County of Fairfax, Virginia

Re: Interpretation for RZ 2010-LE-005 and SE 2010-LE-009, Jennings Business Park, LLC
Tax Maps 90-4 ((1)) 6A and 7: Stormwater Management Facility

**Re: Request for Zoning Interpretation – Proposed Stormwater Pond
Rezoning/Special Exception: RZ 2010-LE-005 and SE 2010-LE-009
Tax Map: 90-4 ((1)) 6A and 7 (the “Subject Property”)
Applicant: Jennings Business Park, LLC**

GENERALIZED DEVELOPMENT PLAN / SPECIAL EXCEPTION PLAT

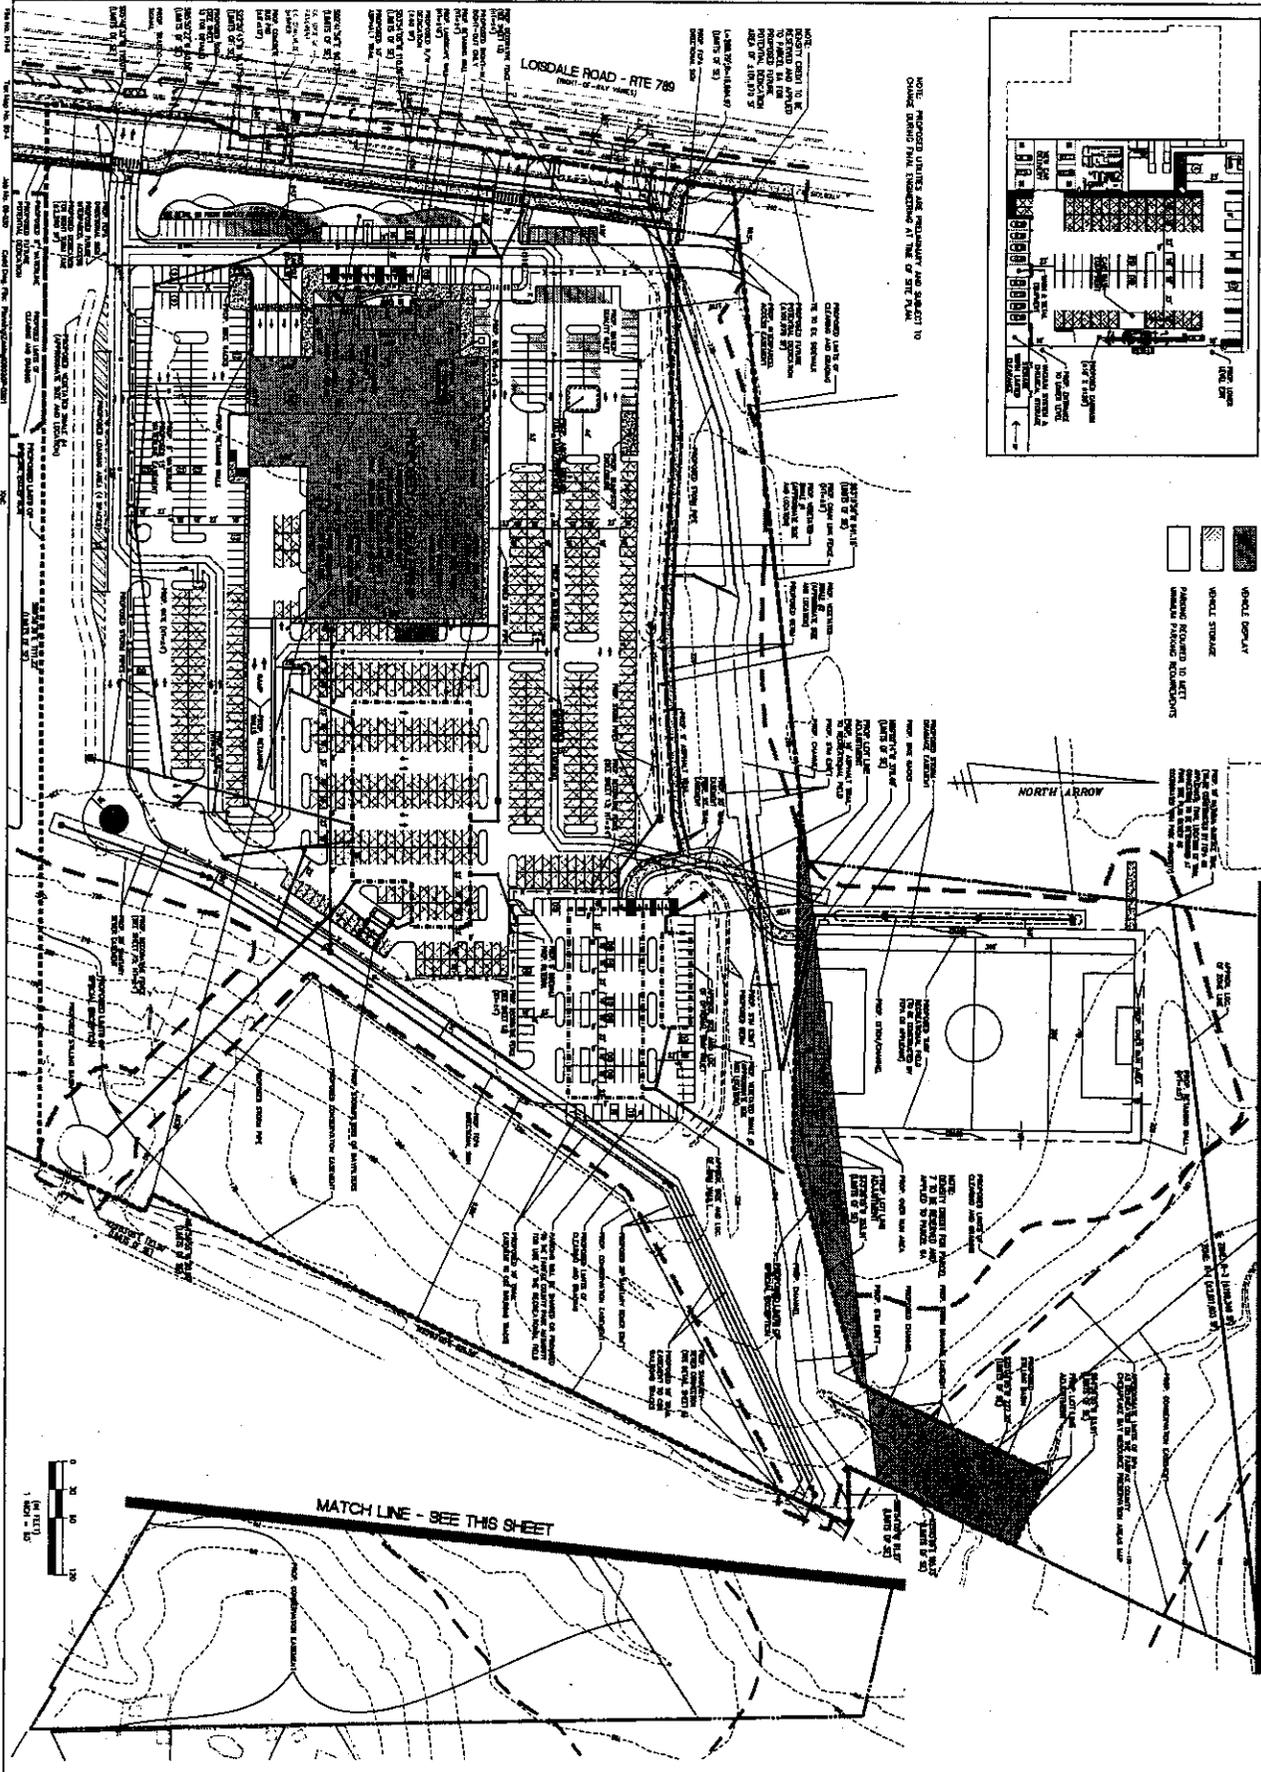
The approved GDP/SE Plat and proffer number 12 propose to handle the project stormwater in two underground detention vaults. The approved GDP/SE Plat also depicted the use of StormFilters or Bayfilters to meet some of the stormwater quality requirements. With this letter, the Applicant requests Staff review as to whether it would be deemed in substantial conformance with the GDP/SE Plat and proffers to construct a stormwater pond in lieu of one of the underground vaults.

Please find enclosed for your review a copy of Sheet 4 of the approved GDP/SE Plat, an exhibit showing the proposed pond alternative, an enlarged sheet showing the proposed pond and tabulation of the revised parking space counts, demonstrating that under the proposed pond option, the project would continue to meet parking requirements under the Zoning Ordinance.

REVISED STORM WATER MANAGEMENT INTERPRETATION EXHIBIT

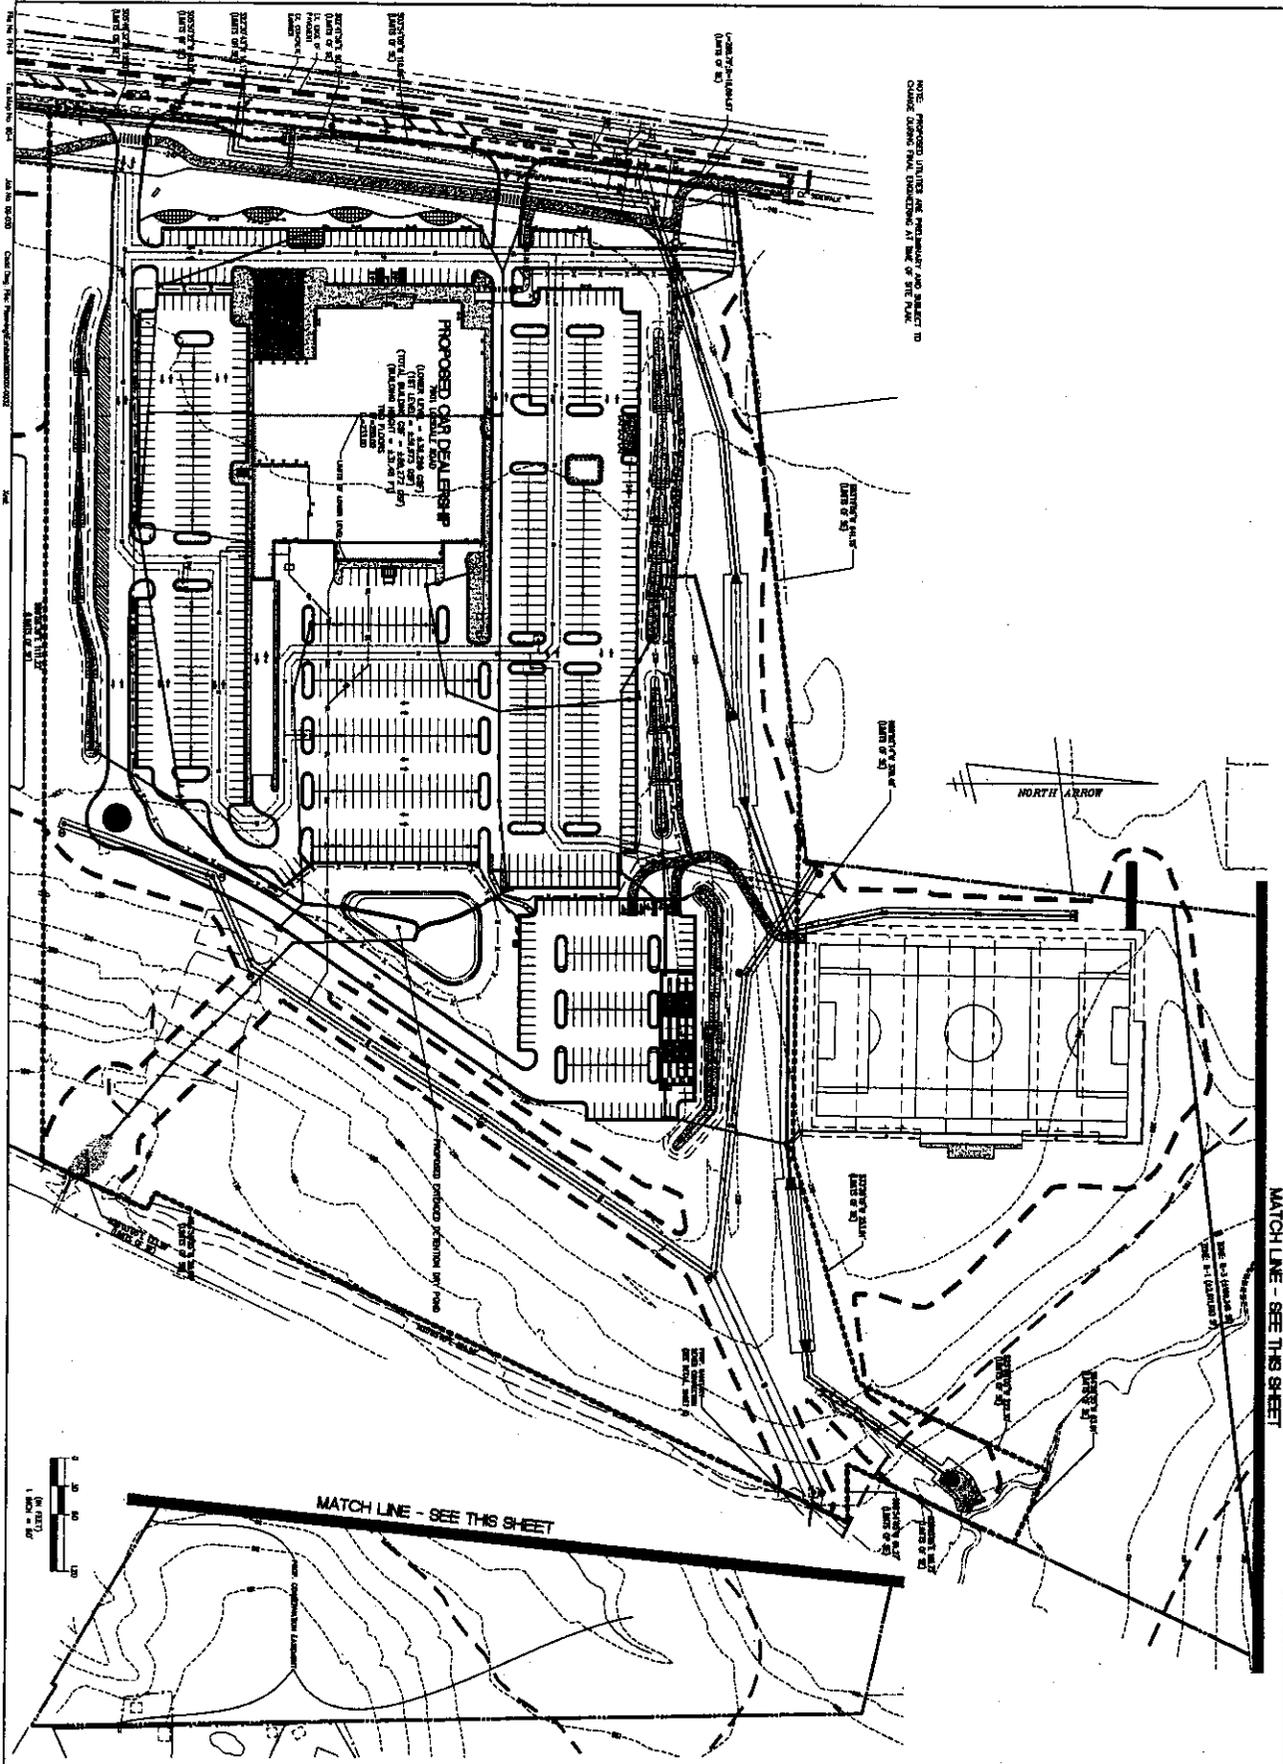
Under the proposed pond alternative, the southern underground vault and the filters would be eliminated and the northern underground vault would remain. The proposed vegetated swales, Filterra, and water quality inlet shown on the GDP/SE Plat will still be provided. The revised layout proposes to construct an extended detention dry pond to meet some of the County

stormwater quantity and quality requirements in lieu of the original underground detention and filters. The County's stormwater quantity and quality requirements will continue to be fully met with the revised concept. The pond will be located where there were some parking spaces and open space shown on the GDP/SE Plat. While there will be 77 fewer parking spaces than shown on the approved GDP/SE Plat, the number of parking spaces required by code will continue to be provided.

Therefore, with this letter, we respectfully request your determination that the proposed stormwater pond as shown on the enclosed exhibit would be considered to be in substantial conformance with the approved GDP/SE Plat and proffers. While the stormwater pond was not shown on the approved Conceptual Development Plan, it does not add GFA, height, additional uses, or intensification of uses on the Subject Property and while parking is somewhat reduced, it continues to meet the Zoning Ordinance requirements. Further, the pond option would reduce the amount of pervious surface on the Subject Property.

It is my determination that the proposed dry stormwater management facility, as shown on the Interpretation Exhibit dated September 1, 2011 is in substantial conformance with the approved proffers and GDP/SE Plat, subject to final approval by DPWES during site plan review and provided landscaping is installed around the pond to the extent permitted by "The Interim Policy Regarding Tree Preservation & Planting In and Around Stormwater Management Ponds," as determined by DPWES.
